UPGRADING BRUSHED TWIN TO BRUSHLESS TWIN COMPRESSOR

07/11/2024

Option A:

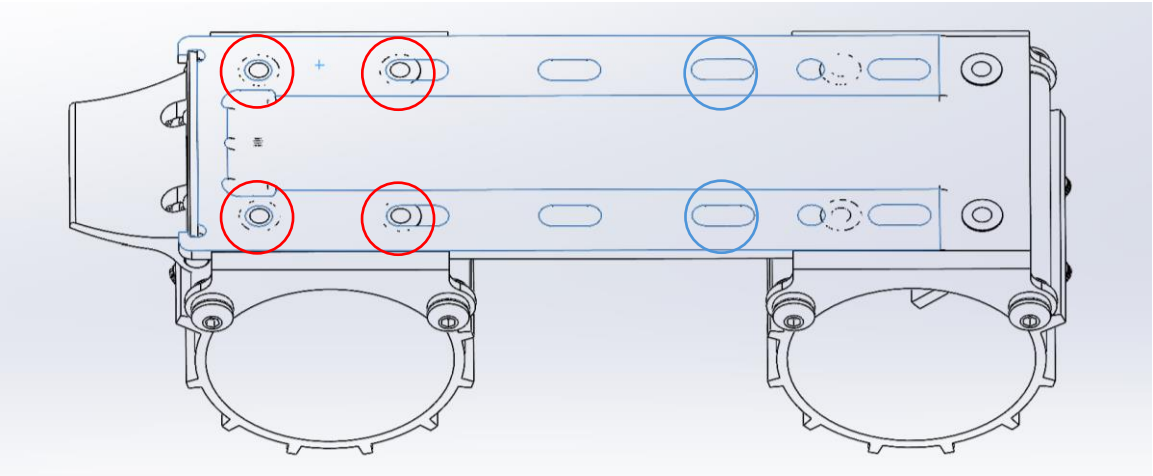
If upgrading a pre-installed brushed twin compressor to a brushless twin it should be noted that due to the new brushless compressor being physically smaller there was no way to fully re-use the mounting hole pattern. However, no more than 2 new holes should be required to be drilled to complete the upgrade.

BRUSHLESS MOUNT HOLE PATTERN OVERLAID WITH BRUSHED TWIN MOUNT

SLOTS ALIGNED WITH BRUSHED CKMTA12 BOLT PATTERN

NEW HOLES REQUIRED

To illustrate the size difference between :
(BRUSHLESS TWIN SHOWN SITTING ON TOP OF A BRUSHED TWIN MOUNT)

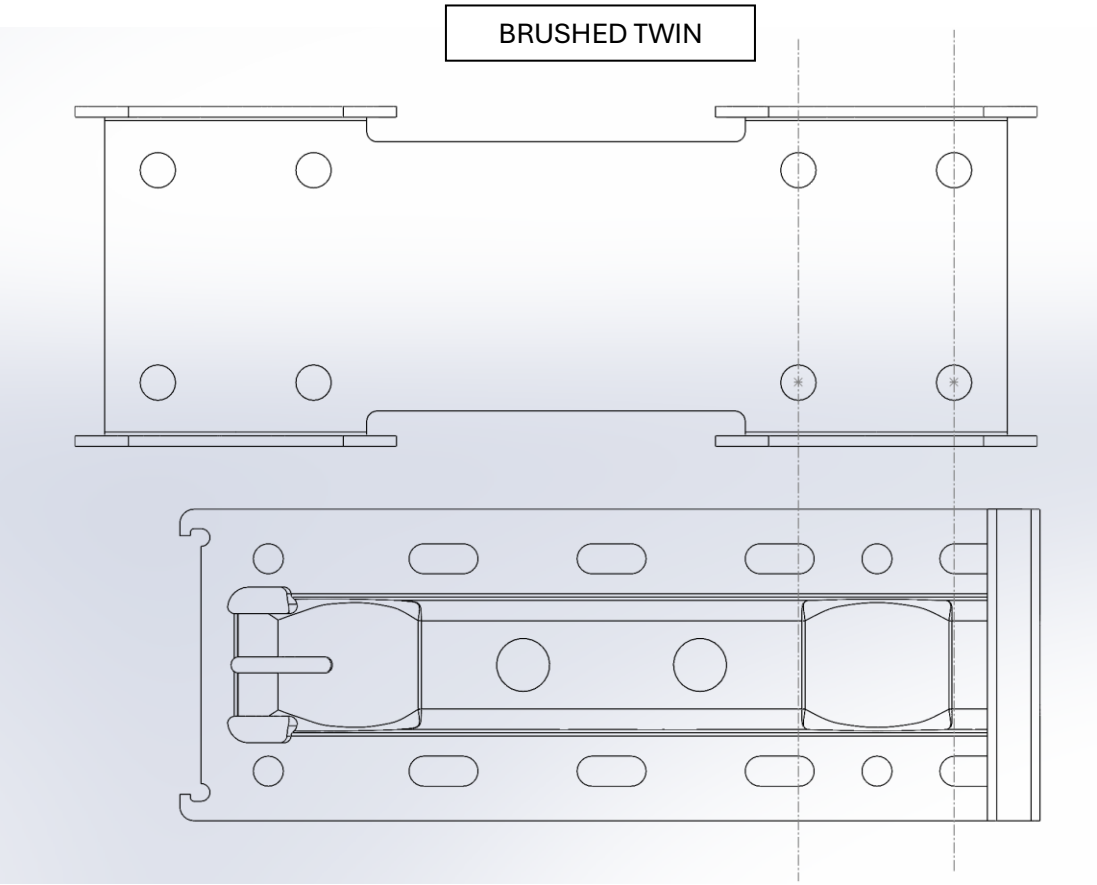
BRUSHED TWIN

BRUSHLESS TWIN

PLEASE NOTE : The wiring harness from the brushed twin air compressor MUST be completely replaced with the harness that is included with the brushless twin compressor.
